Revised Connecting Rod Design on 2001-2017 GM 6.6L Duramax Diesel Engines

The AERA Technical Committee offers the following information regarding a revised connecting rod design for 2001-2017 GM 6.6L Duramax diesel engines. This design change occurred sometime during the 2010-year model. The rod bearing set also changed.

Figure 1. Identifying First & Second Design Connecting Rod Bearings

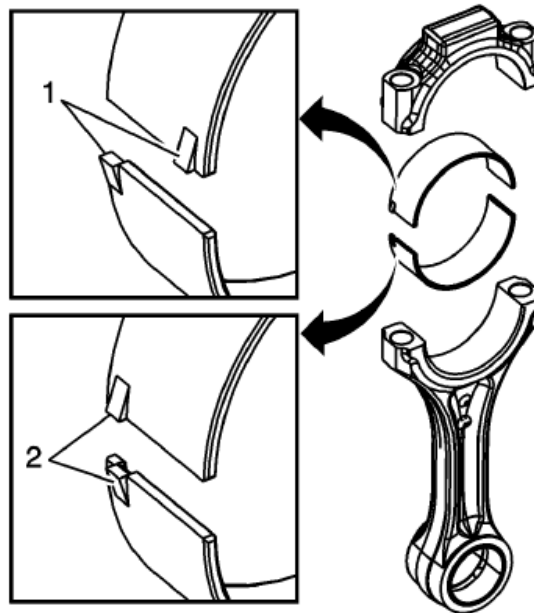
The position of one of the two bearing locating notches in the connecting was moved to the same side as the other one. So now, in the field there may be either design used. There is first design (1) and second design (2) connecting rod bearings and rods as shown in Figure 1 below. Install the connecting rod bearings with the notches orientated as shown.
